CENTRAL SALINAS VALLEY AREA PLAN

FORT ORD MASTER PLAN

Estimated Acreage Overlying Seawater Intrusion Pressure 180-Foot Aquifer

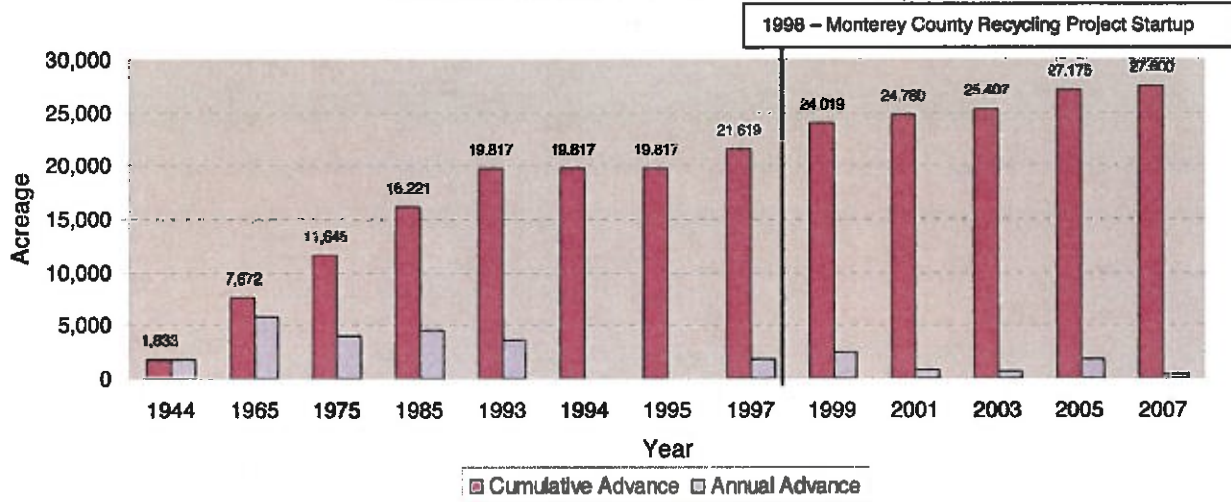
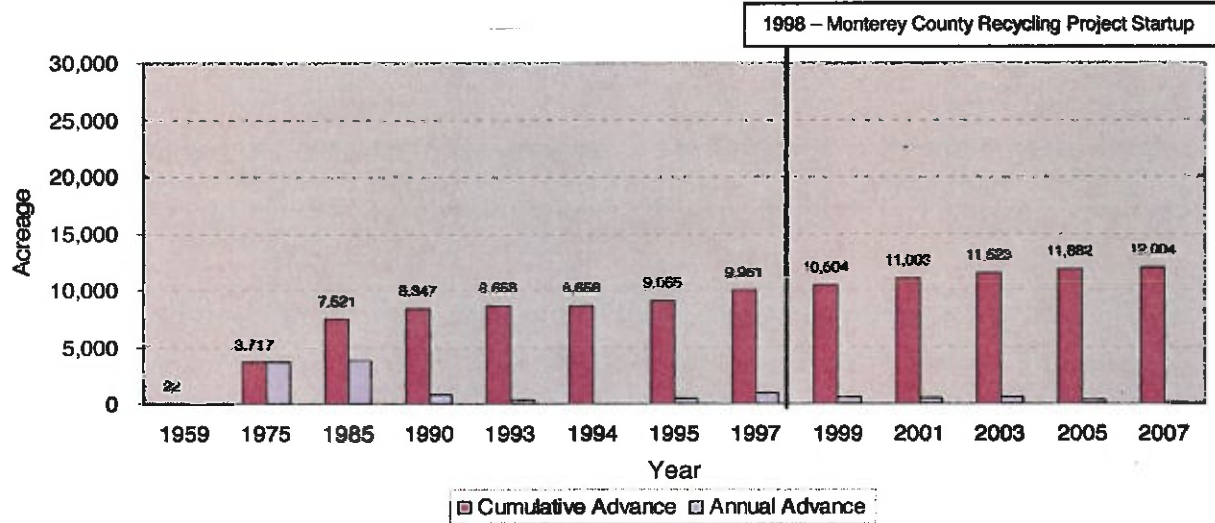
Commenters have noted that the data in Table 4.3.3 (Estimated Acreage Overlying Seawater Intrusion) of the DEIR stops at 1999. More recent data is available, and is illustrated in Exhibit W-2.
